September 28, 2012

Re: ENERGY STAR for Windows, Doors, and Skylights – Version 6.0 Proposed Product Specifications

Table 5: Average Incremental Product Costs

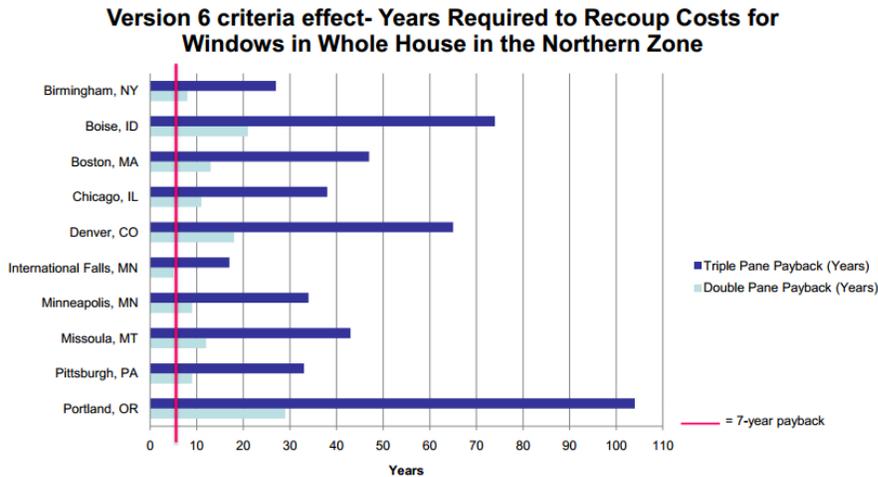
To accurately report incremental product cost effectiveness throughout the Northern Climate Zone, any analysis must include triple-pane windows in developing and correctly reflecting payback conclusions.

The exclusion of triple-pane windows in the EPA cost analysis, severely understates the conclusions made throughout the “Cost-Effectiveness” portion of Draft 1. Without the inclusion of data on triple-pane windows in Table 5, consumers will be misled on product payback and cost-effectiveness.

Based on an AAMA survey, the average cost increase over Best Selling ENERGY STAR windows resulted in more than doubling the estimated payback time. **In fact, the AAMA data proves the average cost to be more than double the EPA estimated \$34.00 cost increase.**
